Stating that, as the best opinions obtainable on the whole question of protection of light houses from lightning will be sought, it does not seem advisable to make a reference to Messrs Chance Brothers regarding the lightning conductor of the light house at Point Divi.

1895-
Public Works Department.

Lightning Conductor of
the Light House at
Point Dui:-

Sketch of Wind vane.
 Point Pine light house.
 — " —

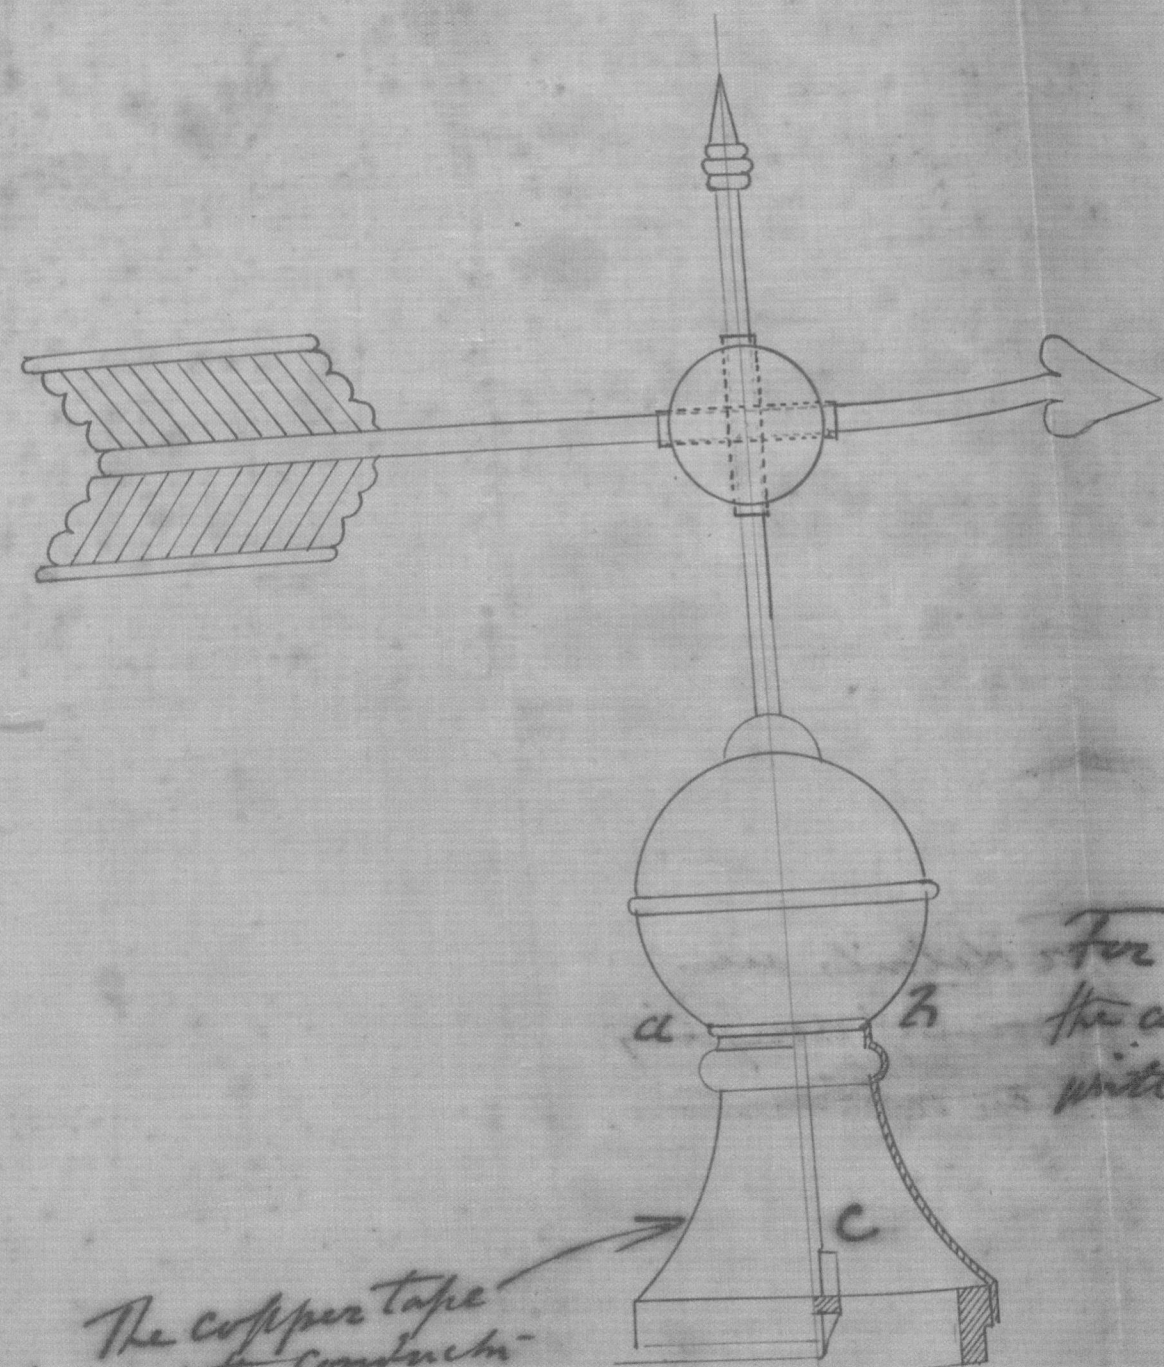
The copper tape
 forming the construction
 is attached to the
 lower part of the frame
 of the wind vane.

Sketch of Wind Vane of Point Ledge Lighthouse.

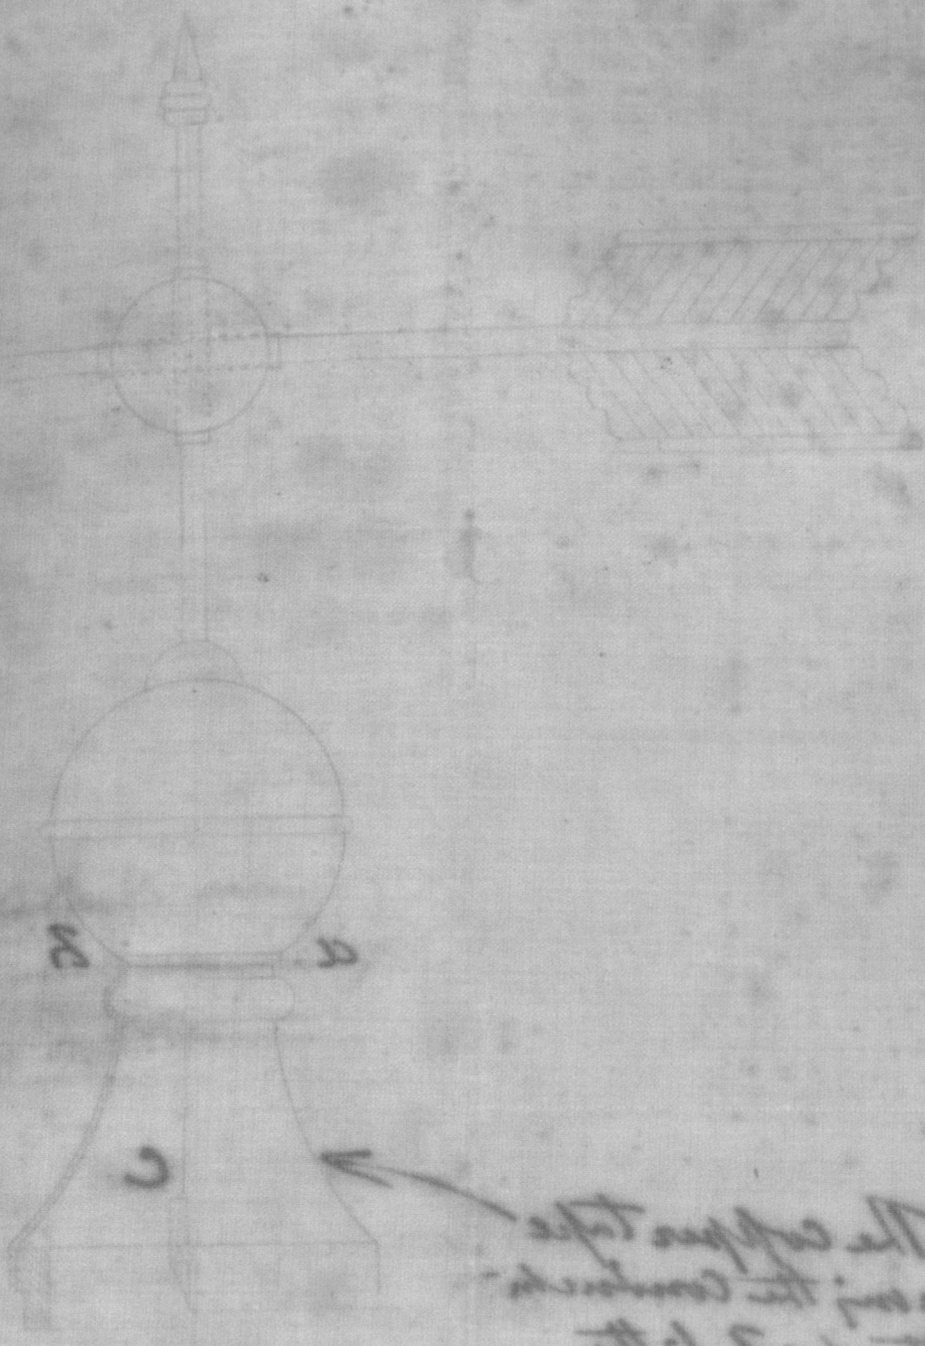
The whole length of spindle copper ball revolve. The spindle pivotted at c. The frame of the vane below the line ab is attached to the dome of the lighthouse. There is no difficulty in making electrical connection between part of the frame and the hanging conductor tape.

It is found however in practice that the remainder of the wire is not in electric contact with the conductor, the reason is apparently that the contact at c is not sufficient for electrical purposes. What is required is some simple method of joining the spindle and the copper ball above ab, in electric contact with the lower part of the frame as before stated the difficulty in making an electrical connection between the lower part of the frame and the hanging conductor tape.
